City of Alexandria, Virginia

SUBJECT: 5th CONCEPT REVIEW OF 2 DUKE STREET
(FORMERLY ROBINSON TERMINAL SOUTH)
BAR CASE # 2014-0113

BAR Work Session No. 5 Submission

BUILDING #3 ELEVATIONS

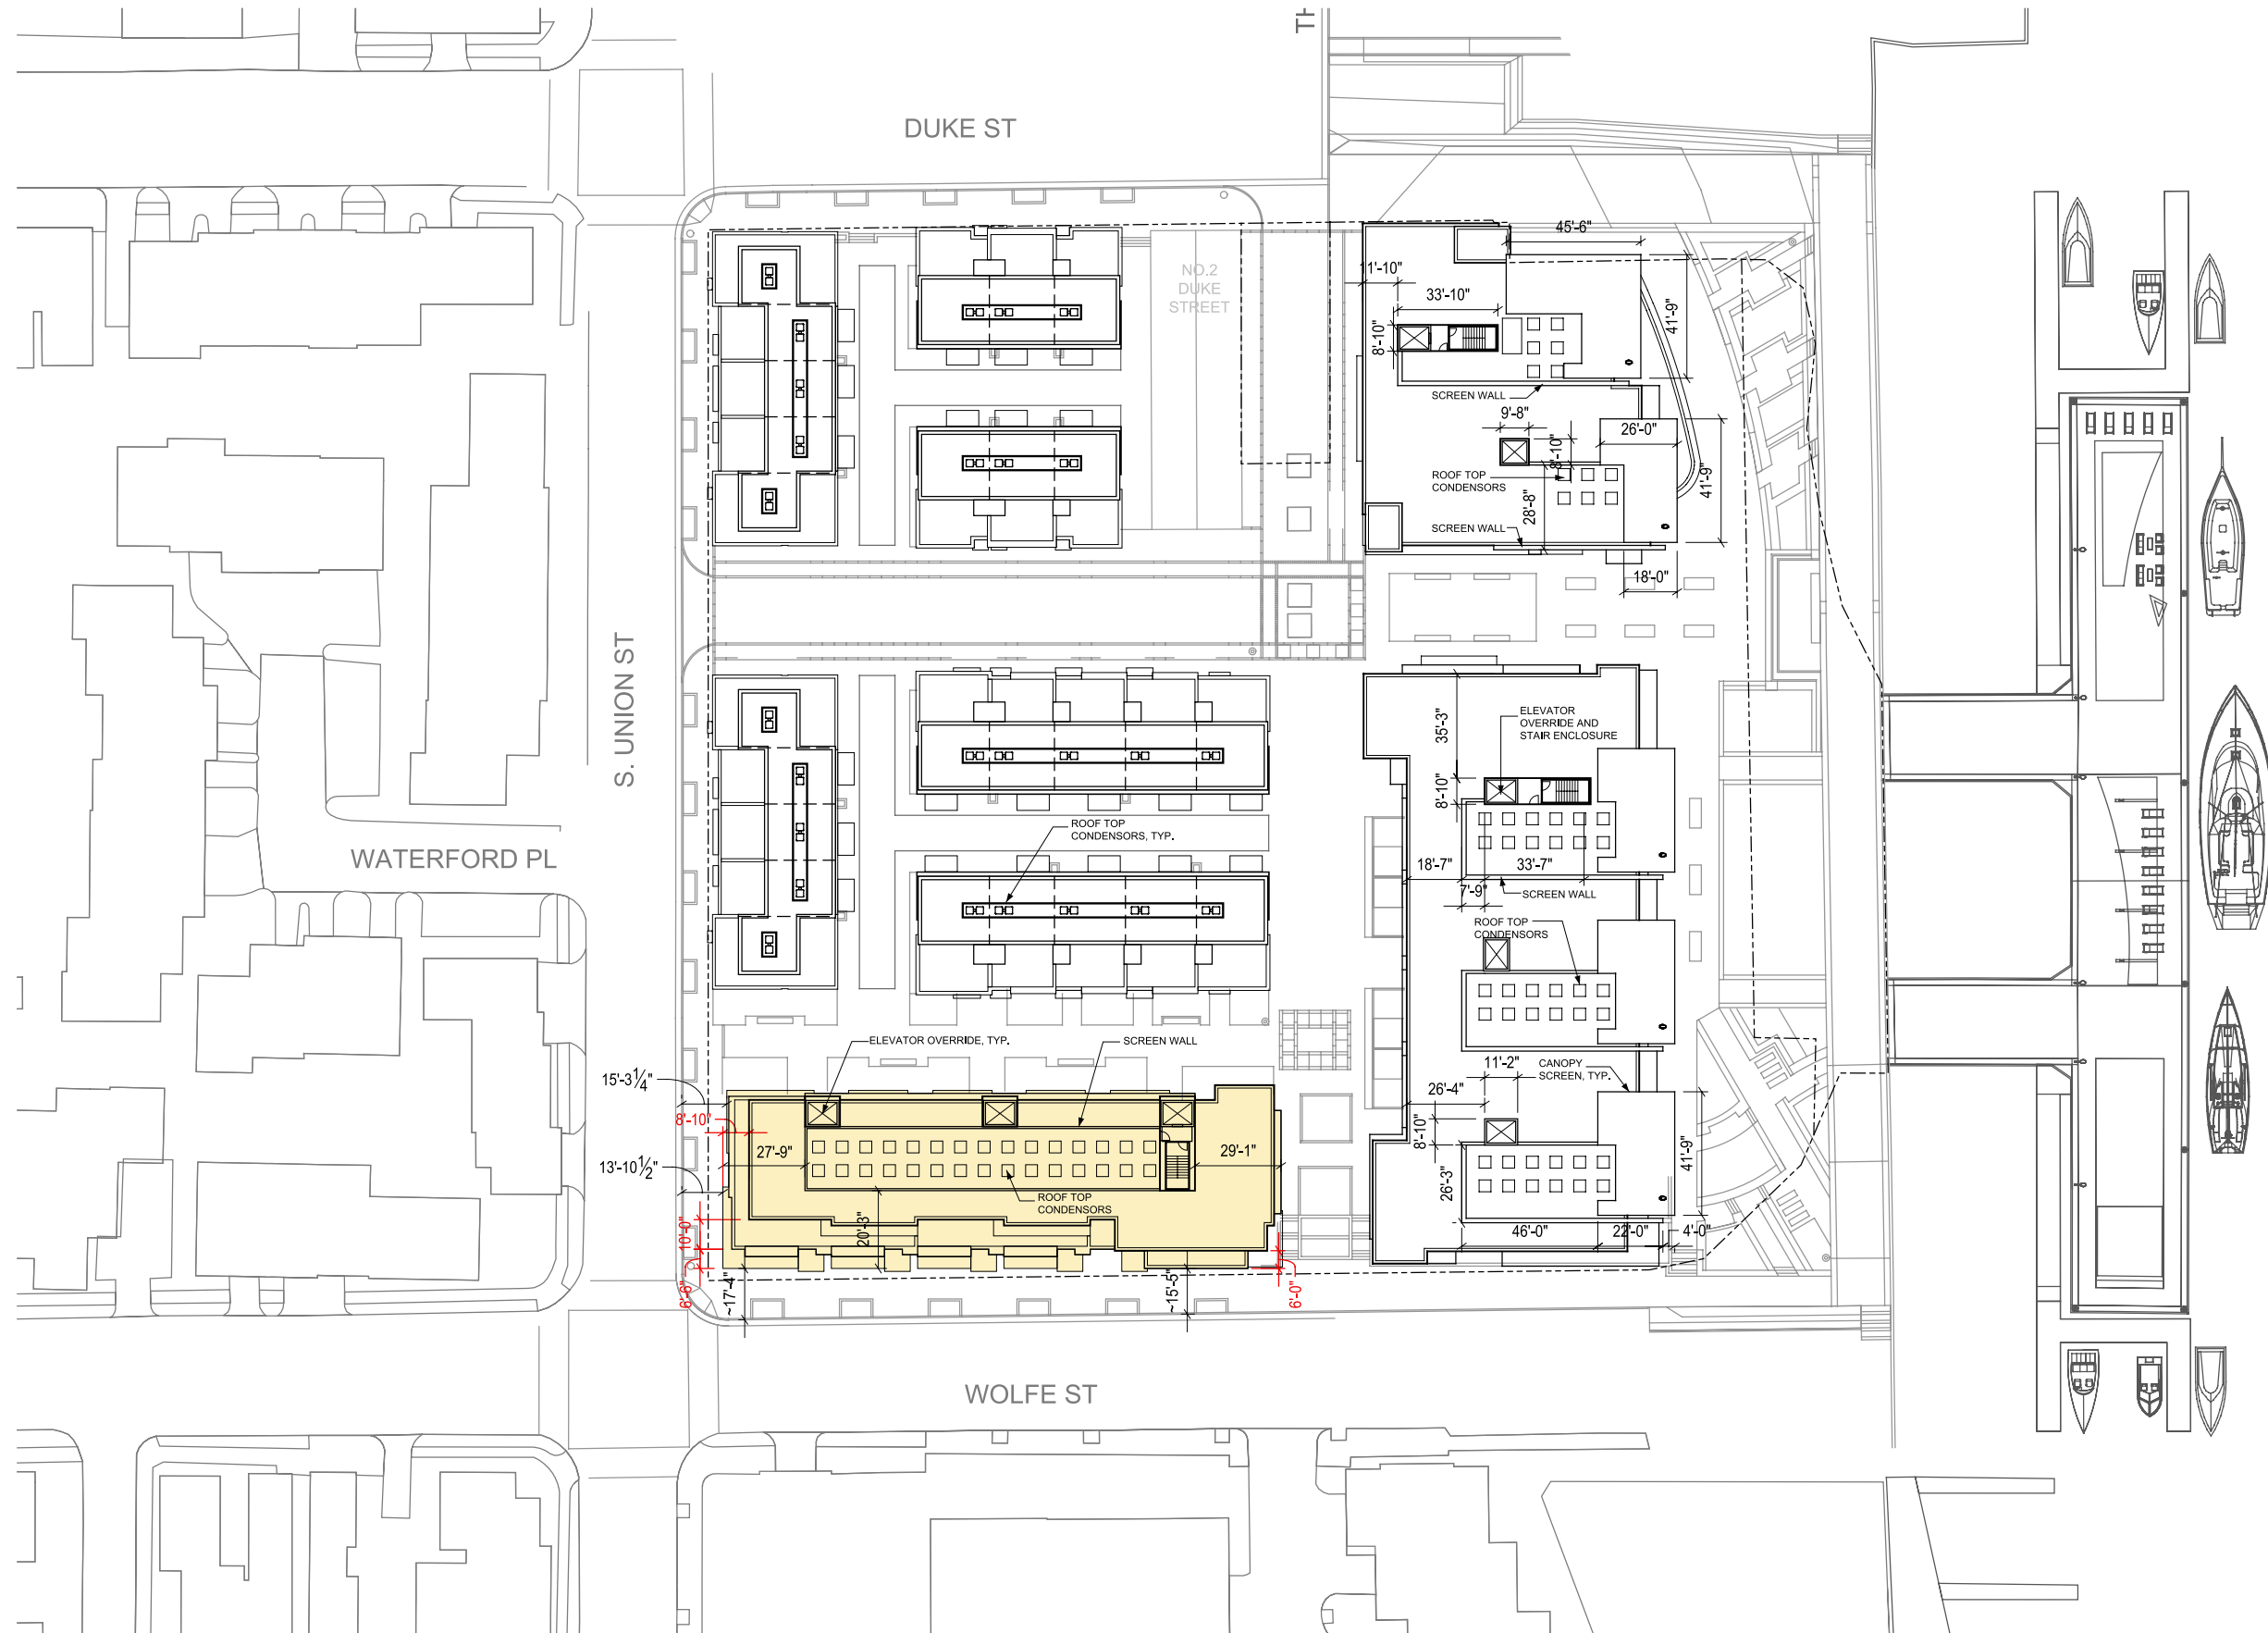
Ms. Roberts appreciated the changes made and the model. Regarding the eastern third of Building 3, she expressed concern about how it read and recommended giving it its own separate identity so it was not part of the larger composition. She suggested changes to make it read as its own distinct building, such as by having its own entrance. She supported the project and recommended these changes be pursued for the Certificate of Appropriateness. Overall, she liked the project's amount of open space and lower overall floor area.

Ms. Miller supported many of the comments made by Ms. Roberts. She said the applicant has listened to the Board's comments over the past work sessions and returned with workable solutions. She would like to see more variety in Building 3, such as making the four "townhouses" each have a different color brick. She also supported a different look for the "apartment building" section. She wanted to continue to see work with the upper level setbacks.

Mr. Neale liked the setbacks and breaking off of the east end into a separate "building." He recommended adding a physical 10 foot wide "alley" break at Building 3 to break down the scale and possibly shift the smaller portion of Building 3 a few feet toward the east. Mr. Youngentob explained that a 10 foot break would be challenging because those alley walls would not be able

to have windows and Mr. Burkhart explained that such a shift would affect the character of the north-south pedestrian connection through the site to The Strand. Mr. Neale thought that the four “townhouses” all looked the same and that they need additional refinement, such as by changing the brick color or introducing different water table materials, etc. He recommended more variety to make them more contextual. He also thought that the two Union Street rows of townhouses needed more variety and “randomness”. He wanted the waterfront buildings to look like separate buildings that evolved over time. He thought the entire project should have more variety and randomness.

1. Increase the architectural differentiation on the east end of Building 3 through changes such a revised fenestration or a change in brick;
2. Incorporate additional interpretation of the site and waterfront history into the plan;
3. Continue to explore multiple brick colors and architectural details to maximize variety and randomness throughout the project.

BUILDING 03 PLAN COMPARISON

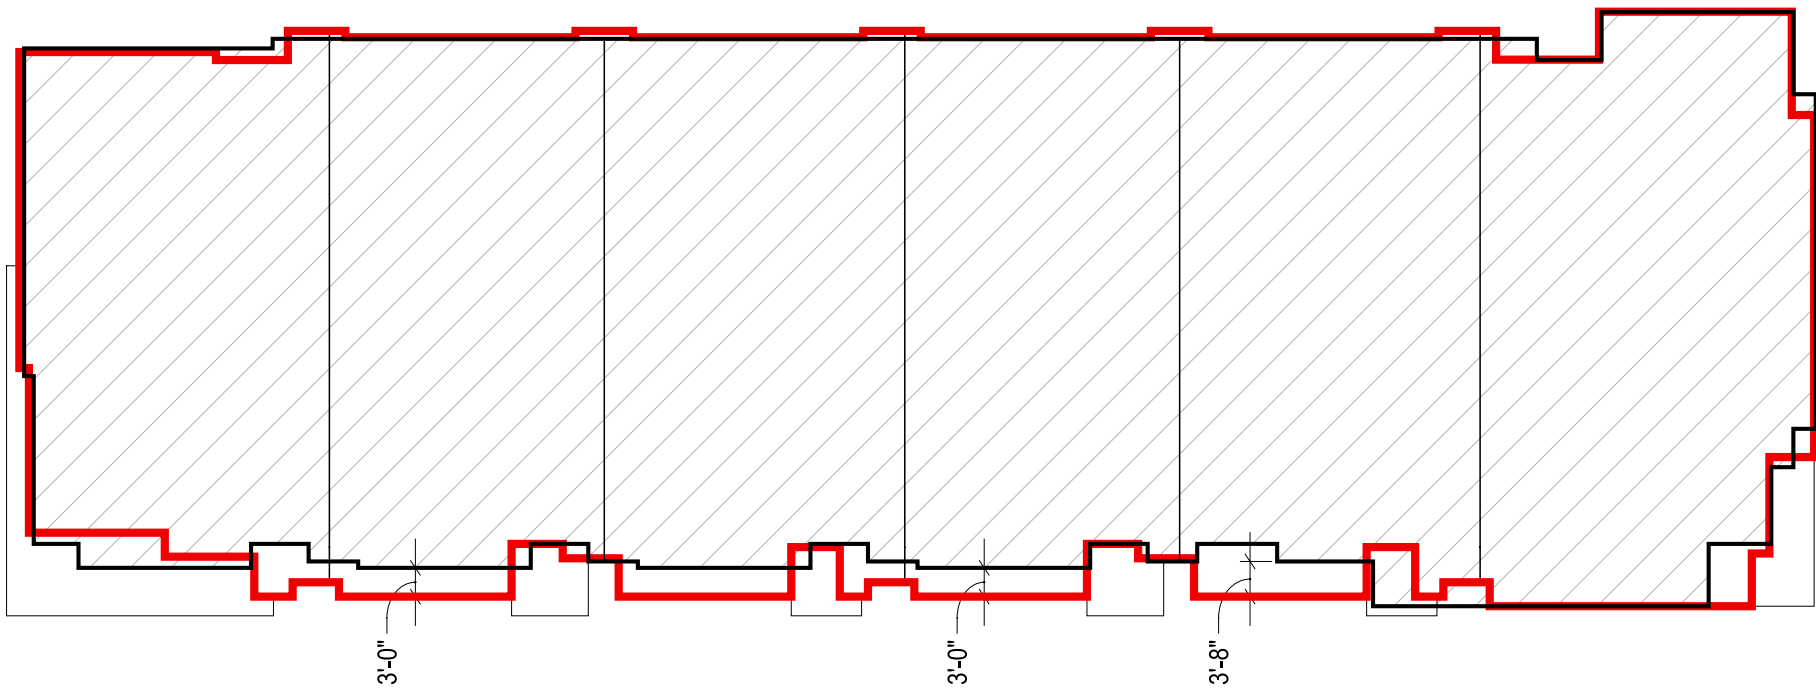
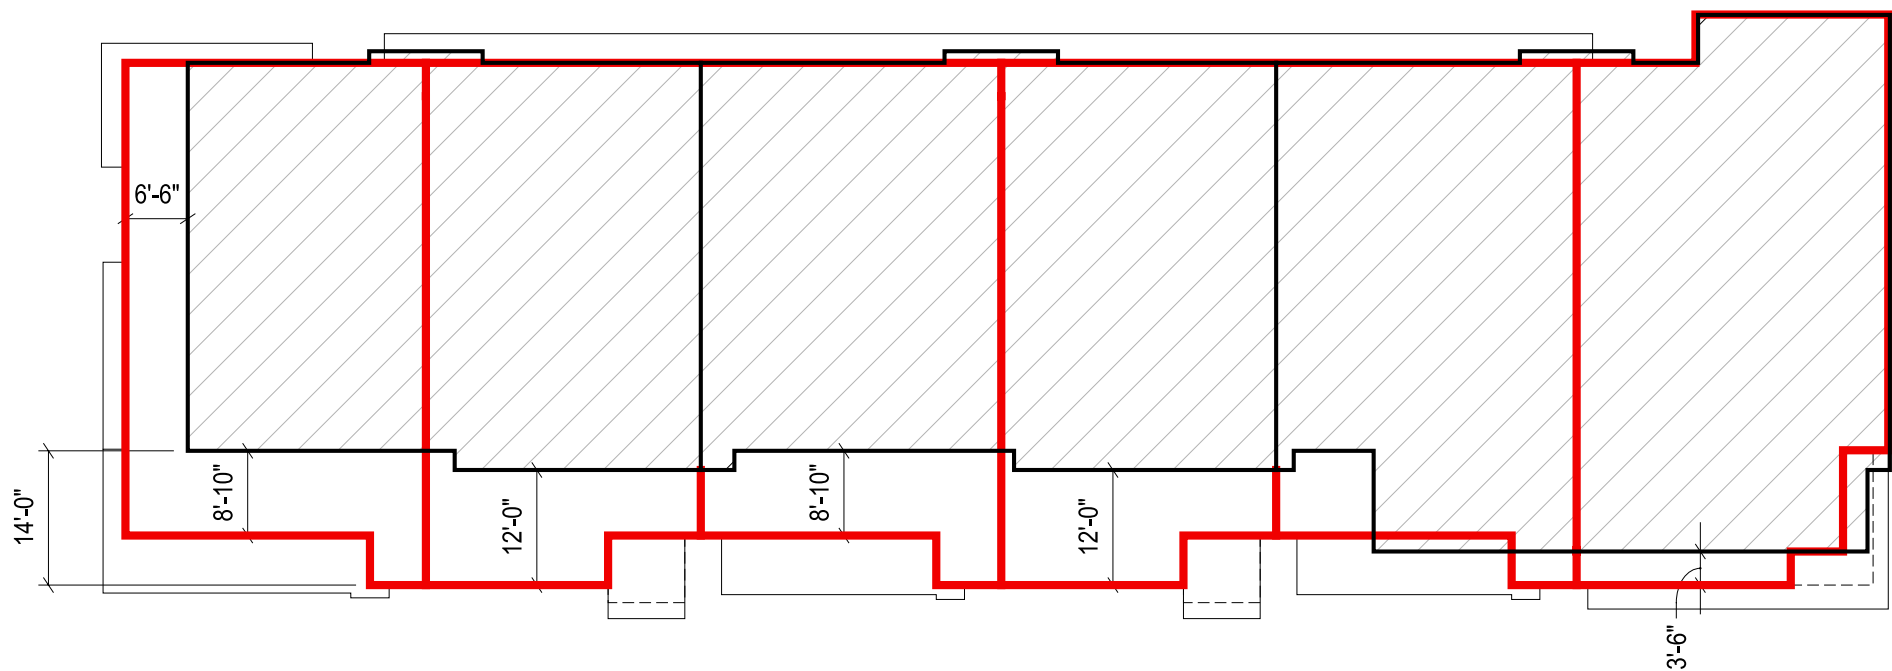
Additionally, the scale of Building #3 has been entirely changed as there is a clear and physical break above the third story (see Building #3 Plan Comparison on Sheet 14). This is achieved by a set back at the fourth story (3') and an even greater set back (ranging from 8' - 10" to 12' - 0") at the fifth story on Wolfe Street. Since the last iteration, presented at work session #4, there has been no increased set back at the fourth story on South Union Street and at the fifth story the set back is 6' - 6". Staff notes that the shift in scale and architectural form is more successful on Wolfe Street and clearly addresses the setback requirements of the Potomac River Vicinity Height District. The combination of the increased upper floor set backs and incorporation of a townhouse rhythm and scale generally results in a much more balanced and appropriate building for this particular location. As this building will be experienced on all four sides, there is also a greater cohesion to the building among all four elevations.

However, to improve the overall cohesion of the building and to improve the transitional relationship with the adjacent block faces, staff recommends that meaningful set backs be added on South Union Street, proportionally similar to what the applicant has done on Wolfe Street. This upper level setback is particularly important on the west end of Building #3, as South Union Street is only 50' wide, where Wolfe Street is a 66' right of way more typical of historic Old Town.

the City Council with the condition that increased fourth and fifth story set backs be employed on the west elevation of Building #3 on South Union Street, similar in scale to those shown on Wolfe Street, and that additional interpretation of the site and waterfront history be incorporated prior to application for Certificate of Appropriateness.
